City of American Canyon  
DESIGN & CONSTRUCTION EXCEPTION REQUEST and APPROVAL

**ATTACHMENT TO CITY OF AMERICAN CANYON  
DESIGN EXCEPTION 1  
01/29/2018**

**APPLICABLE STANDARD: SECTION 3.03A (DRIVEWAYS)**

TENTATIVE PARCEL MAP  
 NACC BUILDINGS A, B, E, & G  
 NAPA AIRPORT CORPORATE CENTER I  
 CITY OF AMERICAN CANYON, CALIFORNIA

SHEET  
**TM4.1**  
 SHEET 14 OF 20

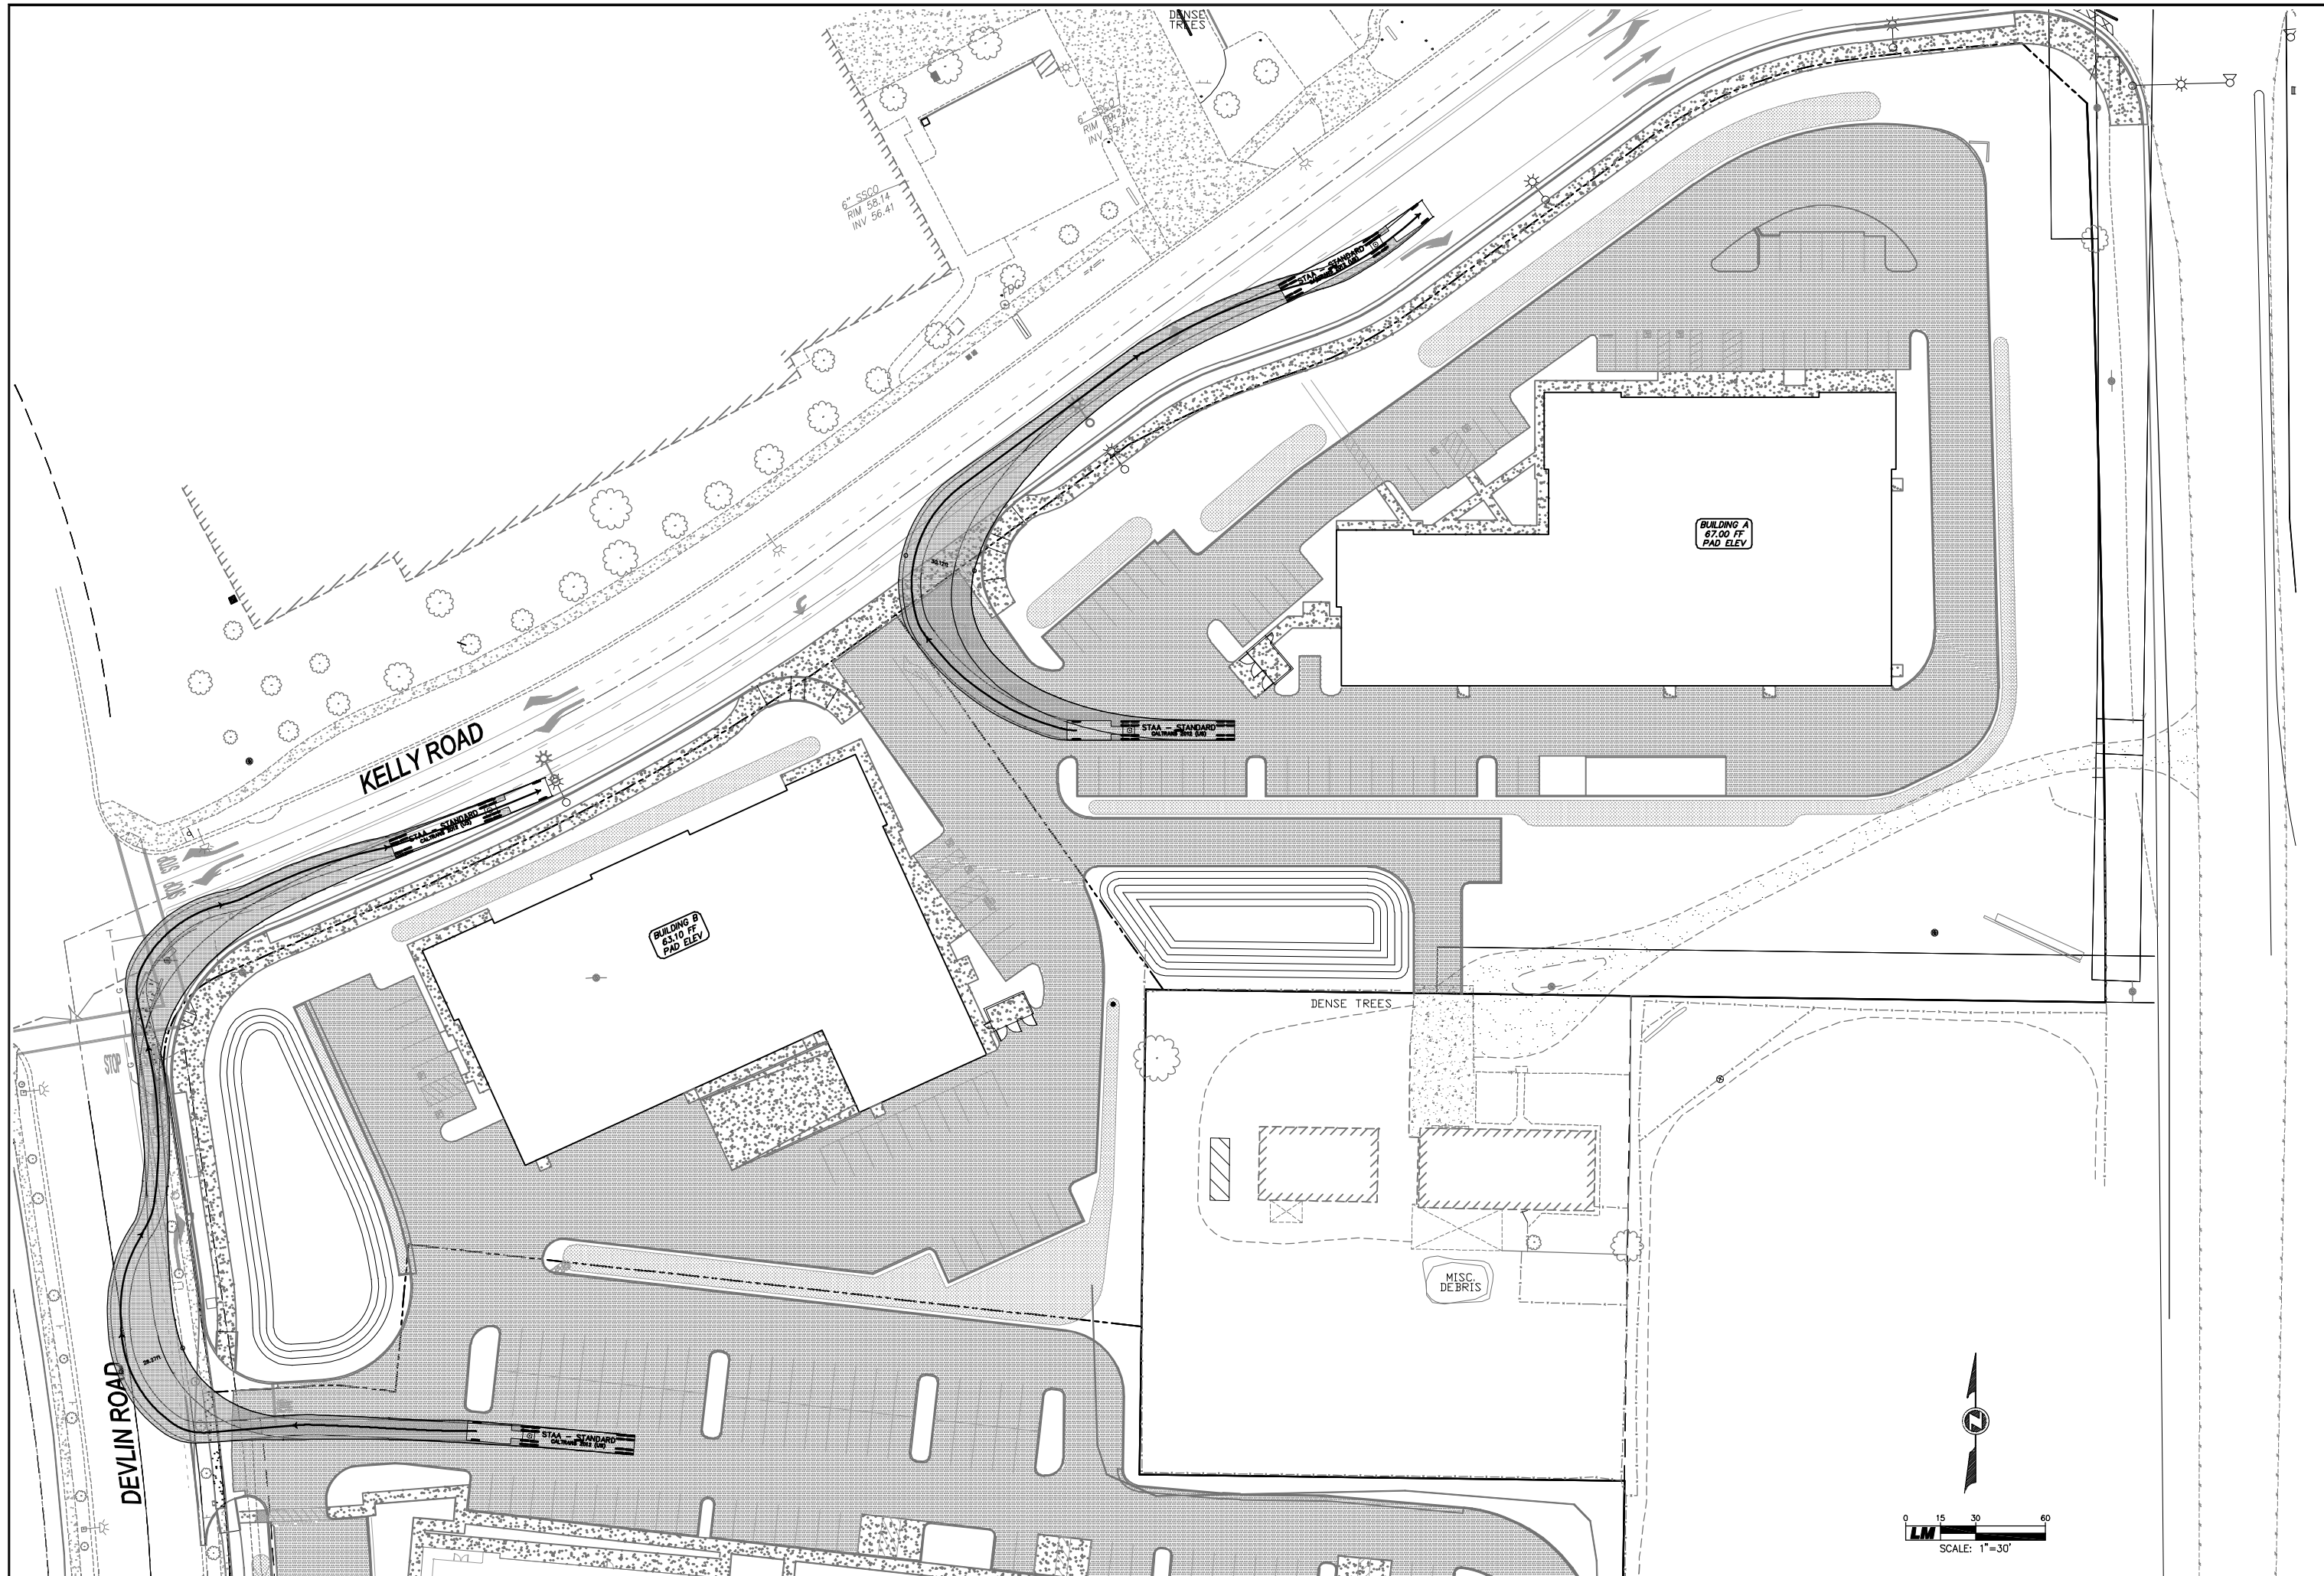
The driveway along South Kelly Road is 70.75 feet wide at the onsite drive aisle. The northerly driveway along Devlin Road is 47.60 feet wide at the onsite drive aisle. Both of these driveways are also proposed as fully depressed (no driveway ramp) driveways. The combination of the increased width and fully depressed driveways are required due to the ingress and egress truck movements.

The increased width of the driveway is required to reduce conflicts with the turn movements and the proposed curbs. The fully depressed driveway allows for a standard layout with curb returns on both sides of the driveway, eliminating the need to have a curb layout with compound curves due to the turn movements. These layouts also provide an ADA compliant path of travel for the proposed vine trail across the driveway.
